TP183518 AND TP183519 SETS OF PARTS, TP182793 HEAT SINK PLATE
AND TP180000 CODE BAR BASKET

APPARATUS AFFECTED: 33A, 33A-1, 33A-2, 33A-3, 33A-4, 33B, 33C-1, 33C-2, 33C-3, 33C-4, 33C-5, 33D, 33D-1, 33D-2, 33D-3, 33D-4, 33E, 33F, 33F-1, 33F-2, 33F-3, and 33F-4 Teletypewriter-Sets.

OBJECT: To improve the operation of the teletypewriter-set by replacing and/or modifying old style parts.

SECTION 574-100-800.15

Fig. 9

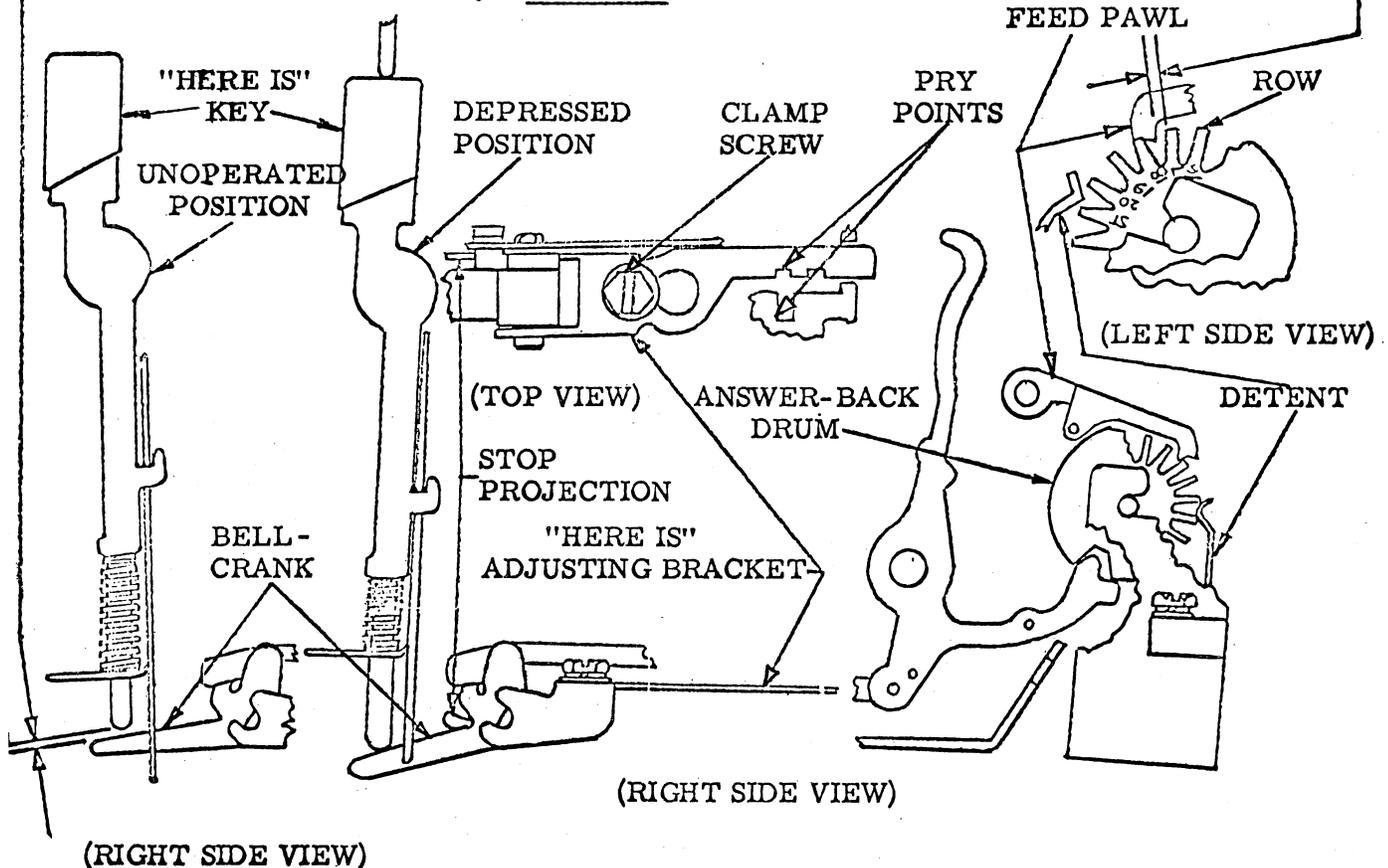
The TP180830 bracket (see page 2-24) (component of the "HERE IS" mechanism) has been modified to include a stop projection to one of the two extensions in order to prevent excess travel of the TP180831 lever.

Requirement: Early design typing units equipped with HERE IS adjusting bracket without a stop projection. Min. 0.015 inch---Max. 0.030 inch overtravel between feed pawl and face of answer-back drum feed ratchet tooth of row "17".

Late design typing units equipped with HERE IS adjusting bracket with a stop projection. Min. 0.025 inch---Max. 0.045 inch overtravel between feed pawl and face of answer-back drum feed ratchet tooth of row "17".

Fig. 10

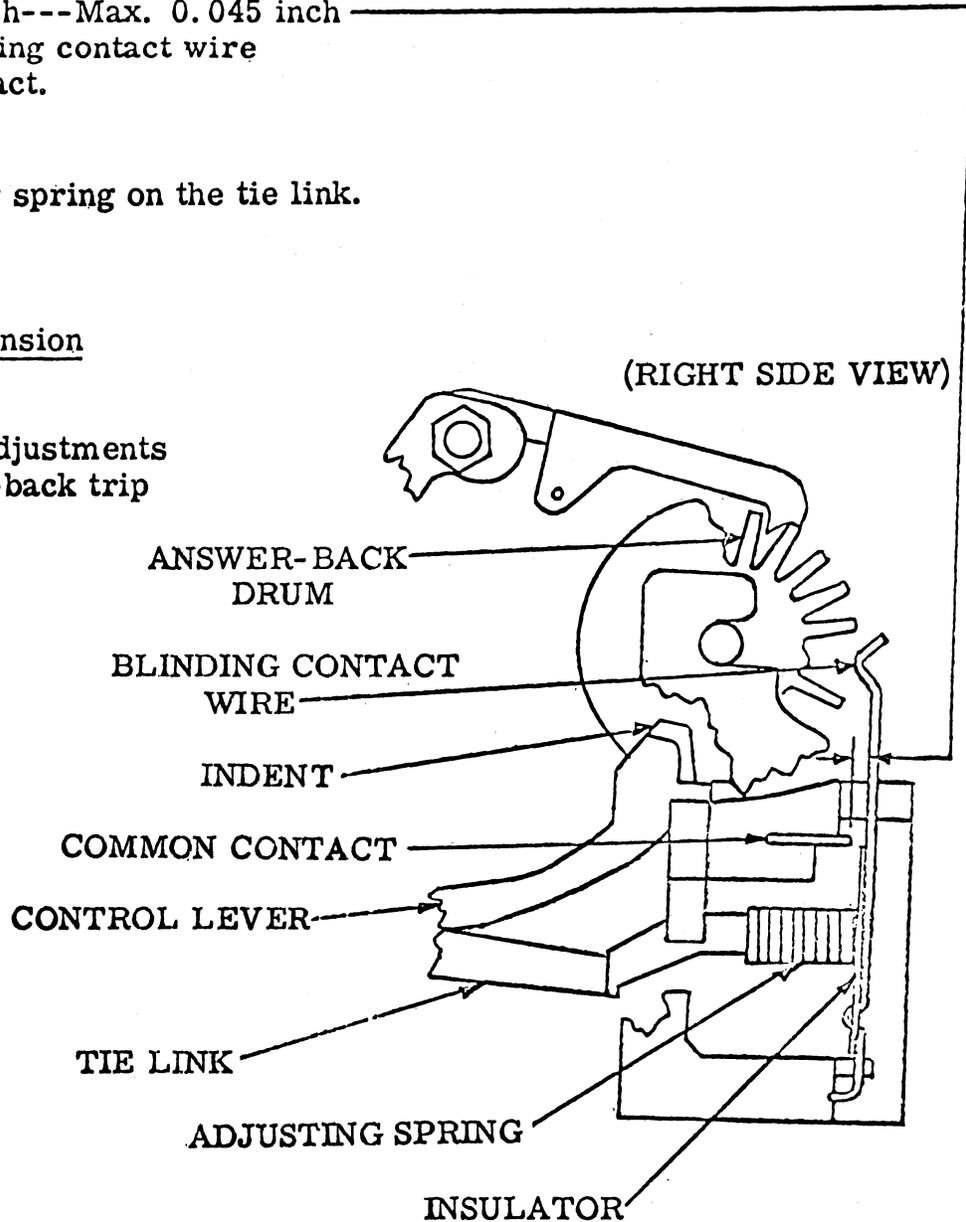
A TP180865 blinding contact adjusting coil and a TP182286 blinding contact fibre insulator (approximately 11/16 inch high and 3/16 inch wide) replace the TP180841 Neoprene insulator (3/8 inch long) (see page 2-24) in the answer-back mechanism. The new TP180865 adjusting coil mounts on the rear of the TP180832 link (see page 2-24) in place of the TP180841 Neoprene insulator.

Note 1: The new TP180865 adjusting coil should be installed and adjusted by rotating it on the TP180832 link in order to obtain the blinding contact wire requirement shown in Bulletin 273B, page 4-83, change 2, and in Section 574-100-703, Issue 2, page 87.

Min. 0.015 inch---Max. 0.045 inch gap between blinding contact wire and common contact.

Position adjusting spring on the tie link.

Fig. 11

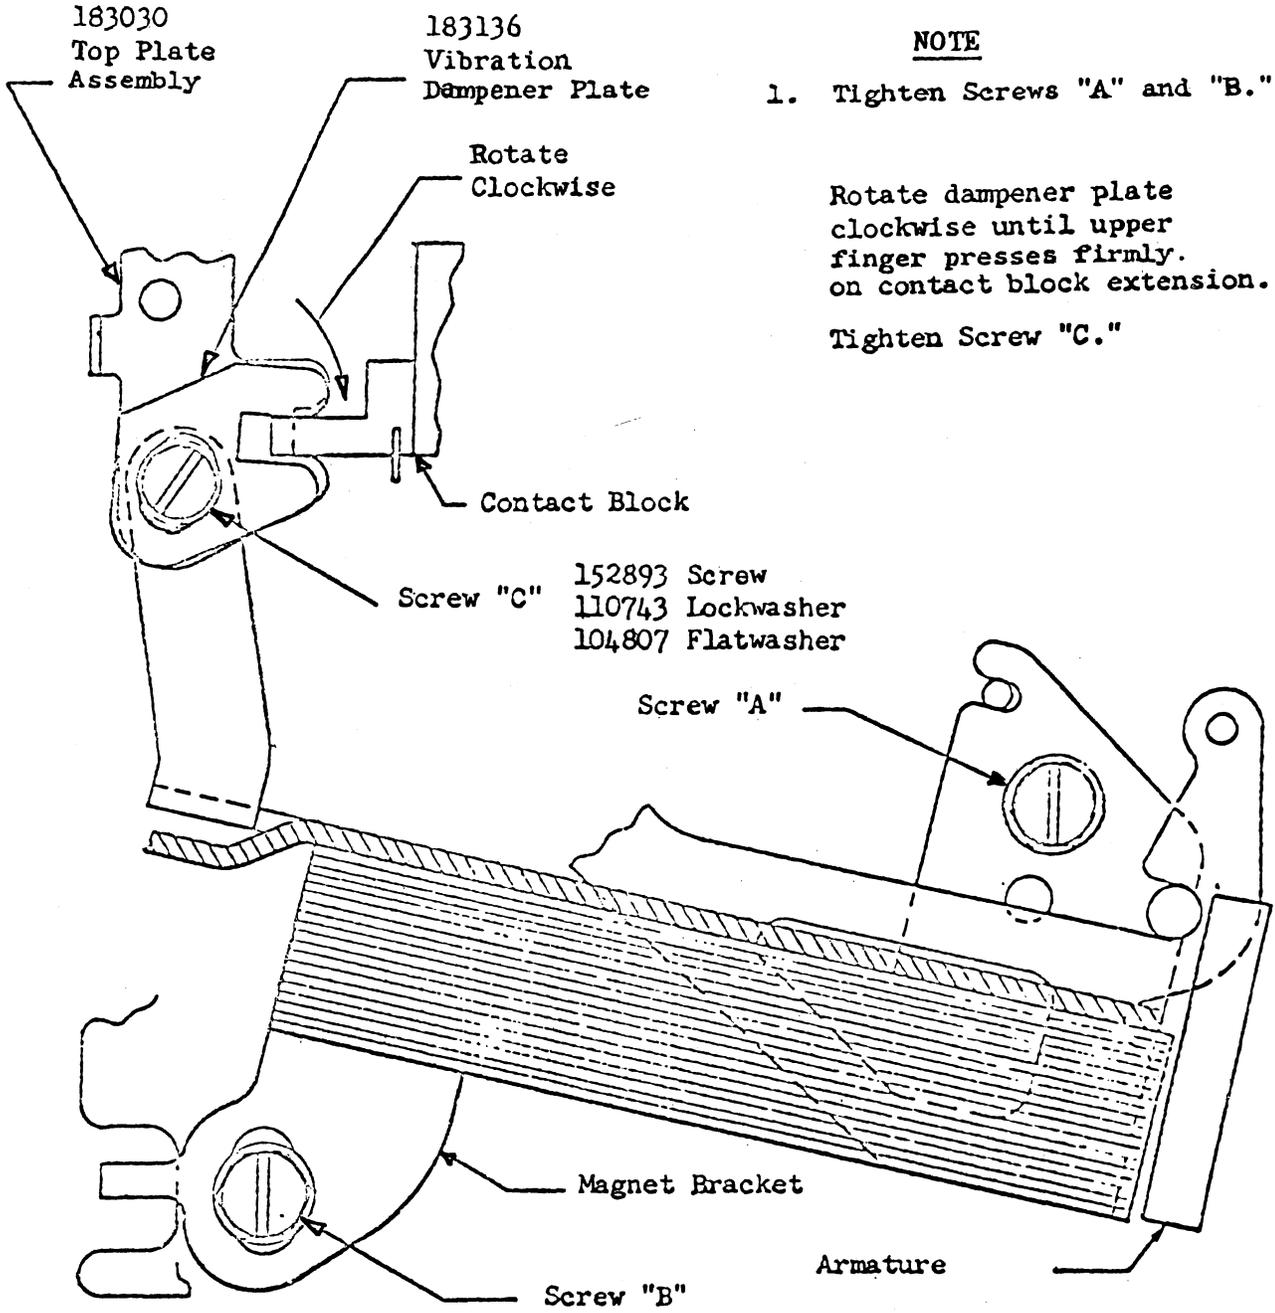
TP183136 vibration dampener plate (resembles the lower section of the outer vertical section of the TP183030 top plate assembly shown as TP183048 top plate assembly on page 6-3) has been added to the tape reader assembly. The new plate mounts to the outer vertical section of the TP183030 by means of a new TP152893 screw (replaced TP151152 screw) and the existing TP110743 lock washer and TP2034 flat washer formerly used to mount the TP183030 top plate assembly to the TP183061 magnet core assembly (see page 6-4).
